# ***Interactive comment on “Water-level attenuation in broad-scale assessments of exposure to coastal flooding: a sensitivity analysis” by Athanasios T. Vafeidis et al.***

Interactive comment on Nat. Hazards Earth Syst. Sci. Discuss., <https://doi.org/10.5194/nhess-2018-359>, 2018.

Fig. 1.

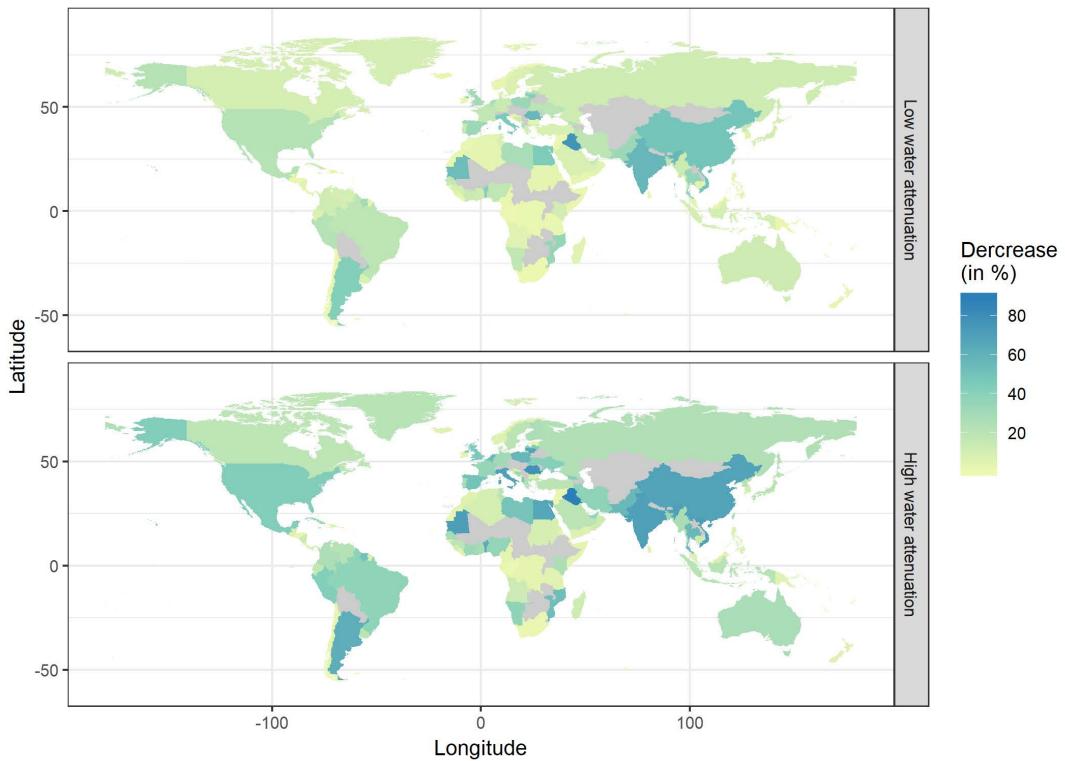
- Tab. 4 I was wondering if an additional map that shows country-by-country results (maybe only for a medium attenuation rate) would be nice to really showcase the spatial variability. The three selected countries can still be highlighted in the table.

We have followed the reviewer's suggestion and compiled a map with this information. This is now included in the manuscript as Figure 4. Further, we added some lines in the text (lines 246-249) to reflect the new figure. The map is attached and the text included now in the manuscript reads: “The reduction in impacts is not uniform across the globe and varies considerably between different countries. Some examples are given in Figure 4 and Table 4. Figure 4 shows the spatial variability of the effects of accounting for water attenuation: low water attenuation can lead to reductions in area

exposure of more than 50% and high attenuation can reduce area exposure by more than 80%.”
